# Providence City Plan Commission

## AGENDA ITEM 5 ■ 663 ADMIRAL STREET

**24-062 MI**  
Preliminary Plan

663 Admiral Street (AP 123 Lots 165 and 166) —zoned C-1

Ground floor site plan

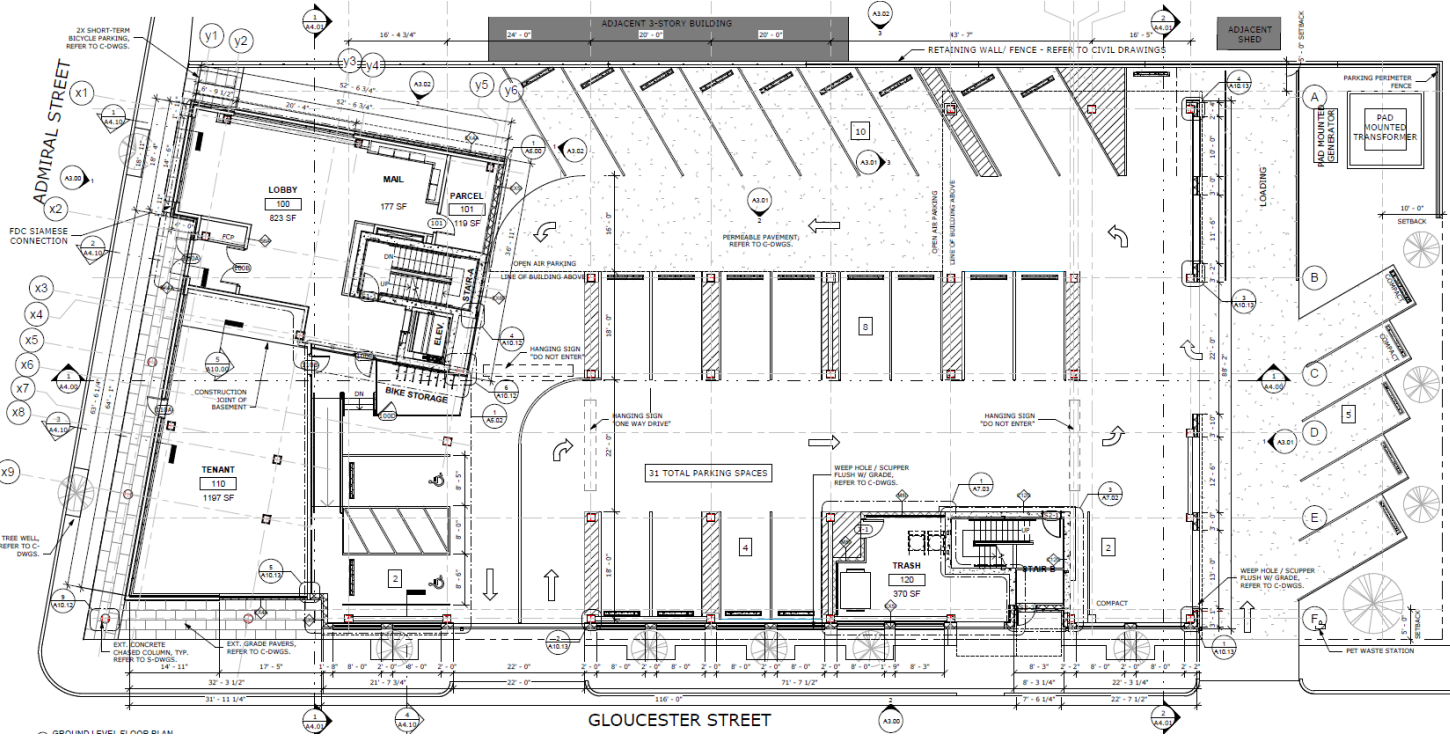
The site is located at the corner of Admiral and Gloucester Streets and will measure approximately 21,026 SF upon merging of the subject lots. Ground floor commercial space will be located at the corner of Admiral and Gloucester Streets with the rest of the ground floor occupied by a lobby, mailroom, bike parking, elevator and stairs. Pedestrian and vehicular access to the parking area which includes a loading space and the transformer, will be provided on the area occupied by lot 171 and accessible from Gloucester Street. This portion of the development will be treated with permeable pavers and will not exceed 65% pervious surface limit of the R-2 zone. A total of 31 vehicle parking spaces will be provided. A dimensional

adjustment for 17 spaces has been requested as 48 spaces are required.

The applicant has requested a parking adjustment to provide 31 spaces where 48 are required, calculated as one space per dwelling unit. The commercial space is exempt from providing parking as it measures less than 2,500 SF in the C-1 zone. The vehicle and bicycle parking area will be provided on the ground floor to the rear of the commercial area and lobby. Three compact spaces will be provided, which will not exceed 10% of the total parking amount. The parking area will be accessed from Gloucester Street with the loading zone and transformer located in the northern portion of the access area. Standard parking spaces will measure 8.5' x 18' and compact spaces will measure 7.5' x 15' which will meet the parking space dimensions required by the ordinance. Drive aisles of 22' and 16' will be provided for non-angled and angled parking respectively.

With the parcel measuring 21,026 SF, approximately 3,150 SF of canopy coverage is required. The site plan shows that plantings are proposed in the northeast and eastern portions of the development. The combination of medium and large trees is expected to meet the canopy coverage requirement.

Part of the area corresponding to lot 171 is paved to provide access to parking. The rear of the lot will be treated with permeable pavers for the loading area and crushed stone for the location of the transformer. The applicant is proposing to meet the canopy coverage requirement by providing street trees along Admiral and Gloucester Street and by making plantings in the parking area. A detailed landscaping plan is forthcoming as a waiver from submission of a detailed landscaping plan has been requested.

1. The subject lots shall be merged prior to final plan approval.
2. A detailed landscaping plan shall be submitted with the final plan.
3. The applicant shall obtain necessary encroachment permits at the permitting stage.
4. Final plan approval should be delegated to DPD staff.
